SIL 09-EP-16
March, 2016
Page 1 of 6

SUBJECT: Energy Storage System 3 (ESS 3) Release Notification

MODELS AFFECTED: H 40/50 EP™ Transmissions

Figure 1. Energy Storage System (ESS)

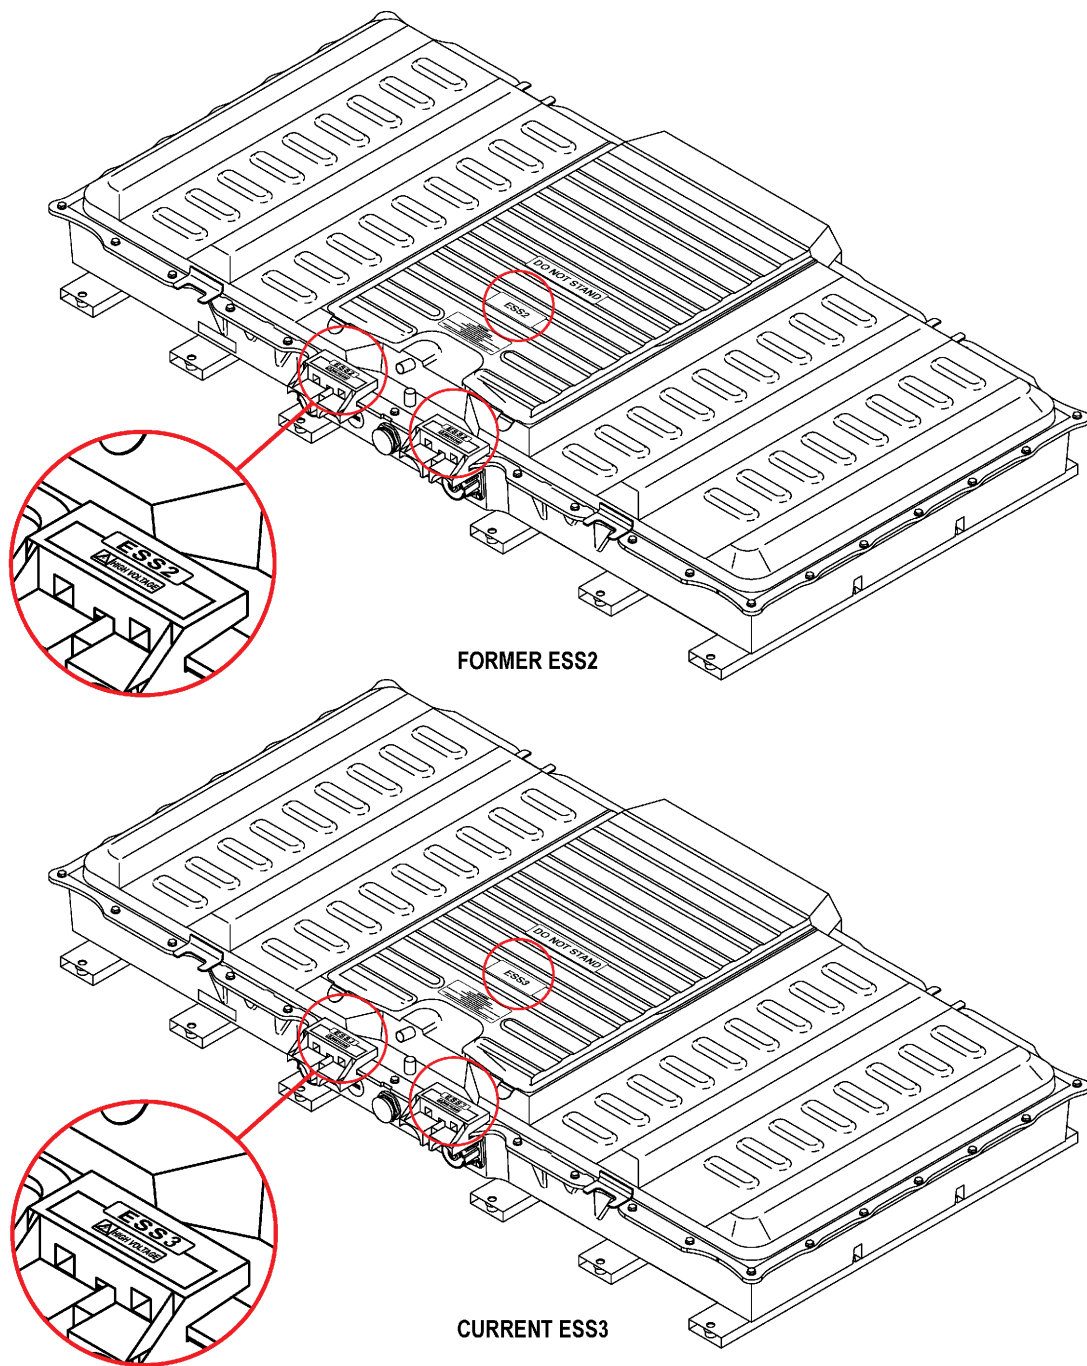
The differences between ESS2 and ESS3 are internal with the exception of some identifying stickers on the ESS cover and HVIL covers (refer to Figure 1). A new System Identification Number (SID) must be Re-flashed when an ESS2 is replaced with an ESS3. The connectors (high voltage and low voltage), pins, mounting points, and external dimensions are identical between the ESS2 and ESS3 making them fully interchangeable assemblies.

Figure 3. TCM Assembly Number

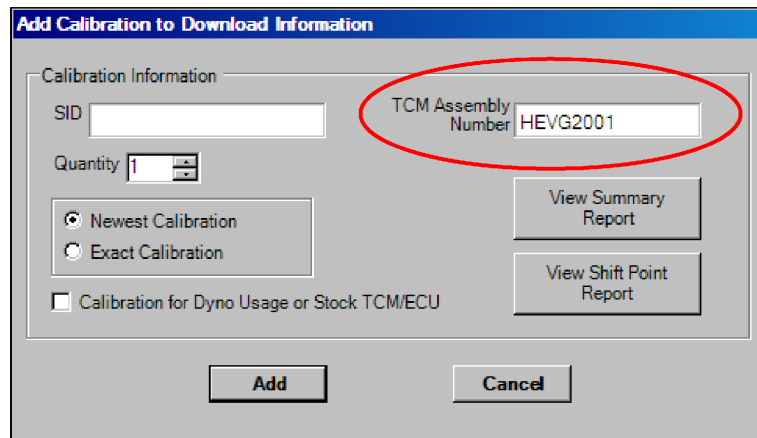
When an ESS1 or ESS2 is replaced with an ESS3, the SID must be updated so the 4th digit matches the new hardware configuration of the system. The rest of the TCM Assembly Number portion of the SID should stay the same, but all other digits may be different. For this reason, the new SID should be downloaded as a TCM Assembly Number rather than a SID (refer to [Figure 3](#)). To download any SID by TCM Assembly Number, add a “HEV” prefix to the TCM Assembly Number portion of the SID. If changing a vehicle’s hardware configuration, change the second digit of the TCM Assembly Number based on Table 1.

Example: A technician is working on a bus with the SID 64-G0001-002-U, Pre MY07, Pre 4th Gen, DPIM1 and an ESS1. The technician determines that the ESS1 must be serviced with an ESS3. After installing the ESS3 the technician would need to reflash the entire vehicle (TCM, VCM, DPIM, and ESS) with the SID VV-XS001-YYY-Z to match the vehicle's new hardware configuration.

Figure 7.
ESS3 BCIM P/N 29558054 With E30 Software

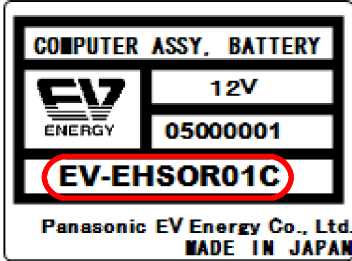
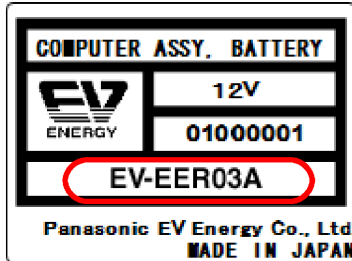
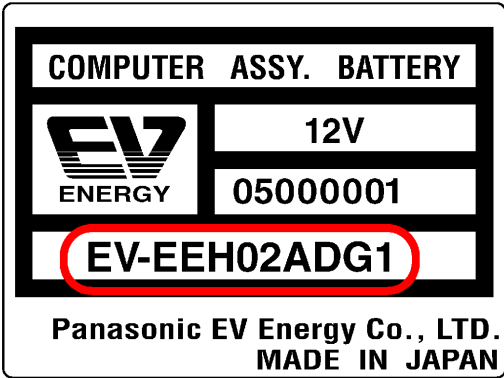
The parts listed in Table 2 are new for ESS3 and are not interchangeable with the former ESS2 parts. Figures 6 and 7 illustrate BCIM differences.

NOTE: Although the ESS2 and ESS3 BCIMs look identical, they have different software. It is important to install the correct BCIM during a repair. Failure to do so will set an active 76-61 Battery Subpack Software ID code and shut down the vehicle's high voltage system. The only way to correct this scenario is to install the correct BCIM. As seen in Table 3, BCIMs can be identified by either their Allison or Panasonic P/Ns prior to installation. Refer to Table 3 and the interchangeability section of this SIL to identify whether you are working on an ESS2 or an ESS3. The software levels of ESS2 and ESS3 are subject to revision, but the middle digit of the software will always remain the same: "2" for ESS2 and "3" for ESS3.
